**INF.10**

### PROPOSALS FOR AMENDMENTS TO ANNEXES A AND B OF ADR

Sections 8.2.1 and 8.2.2: Driver training
Comments in response to INF.3 (ECE/TRANS/WP.15/2009/4)
from the United Kingdom

Transmitted by the Government of Sweden

- 2) We have added a new paragraph in 8.2.2.8.1 to clarify that in cases where an examination is based on a restricted basic training course, this must also limit the scope of the specialization course.
- 8.2.2.8.5 Model for the training certificate for drivers of vehicles carrying dangerous goods

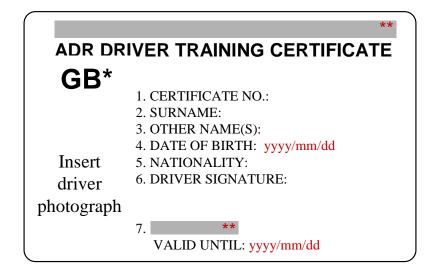
## **Comment to 8.2.2.8.5 (front of certificate)**

- 1) We would like to suggest that the international standard for date and time representations, ISO 8601, is followed in order to avoid any confusion. E.g. in Sweden, ISO 8601 is closely followed in most written documents. Dates are generally and officially written for example "2009-03-31". However, if this standard is not as commonly used in other ADR-countries, we would not really have any difficulties to agree with the year being indicated as in your proposal (dd/mm/yyyy), but we would then like to propose to indicate the year with four digits ("yyyy").
- 2) To avoid differences between the countries certificates, we suggest including some kind of markings that illustrates where the text of a second language (as required in 8.2.2.8.4) shall be displayed.
